4. Hauck's View Subdivision #2
KPB File 2024-010
Johnson Surveying / Hauck
Location: Cohoe Loop Road
Cohoe Area

ITEM #4 - PRELIMINARY PLAT HAUCK'S VIEW SUBDIVISION #2

KPB File No.	2024-010
Plat Committee Meeting:	February 12, 2024
Applicant / Owner:	Richard Hauck of Kasilof
Surveyor:	Jerry Johnson / Johnson Surveying
General Location:	Cohoe Loop Road in Cohoe area

Hauck's View Subd. #2 Preliminary Plat

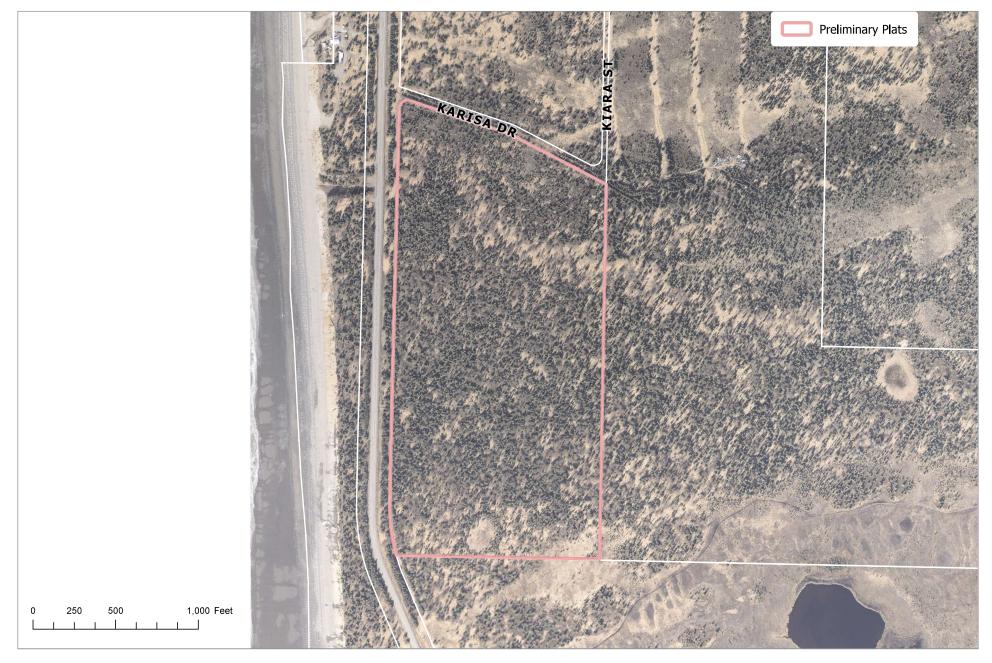
The plat is proposing a dedication of a half cul-de-sac on the east side running along Tract C to be named Kiara St. the surveyor may consider extending the bulb of the cul-de-sac into Tract D to make future development and extension of Kiara St easier as only Tract D would need to be involved. To bust the bulb of the road for extending, any tract adjacent would most likely be involved in the platting and extension of the road.

In the deed filed at serial 2003-0003654-0, there is mention of the property being subject to a 30-foot wide public access easement, the south 30 feet of the described real property in the deed. This easement needs to be shown on the drawing.

There are some wetlands on the plat shown. Upon looking at the KWF wetlands assessment map from KPB data it appears the wetlands cover a little more area than shown. **Staff recommends:** the surveyor review the KWF wetland assessment site and adjust the limits of the wetlands on the plat to accommodate as needed. The

The plat notes indicate a 15' utility easement which is also shown on the drawing as being dedicated by KN 2011-54. Hauck's View KN 2011-54 dedicated only a 10' utility easement in the notes given. Per KPB 20.30.060(D), only a 10' utility easement is required. The surveyor can leave the easement at 15' or change it to 10' if so desired.

HEA has requested that the overhead powerline on the west side of the subdivision be labeled of a plat note be added stating "The existing overhead powerline is the centerline of a 30-foot-wide electrical easement, including guys and anchors, granted this plat." Plat note #3 carried forward from the previous plat states that the easement size is 20'. **Staff recommends:** Plat note #3 be amended to accommodate HEAs request to make easement 30'.

Revise owner name to Richard T Hauck as shown on certificate to plat Add 2024-010 to Kenai Peninsula Borough File

Add Box to the address PO ____ 1096

Label Karisa Drive

To the north, filing label needs corrected

- Roads must meet the design and construction standards established by the borough in order to be considered for certification and inclusion in the road maintenance program (KPB 14.06).
- The borough will not enforce private covenants, easements, or deed restrictions per KPB 20.60.170. Remove the statement "These are KPB imposed covenants" in plat note 4.
- Add reference to note 4 on the certificate to plat to the drawing.
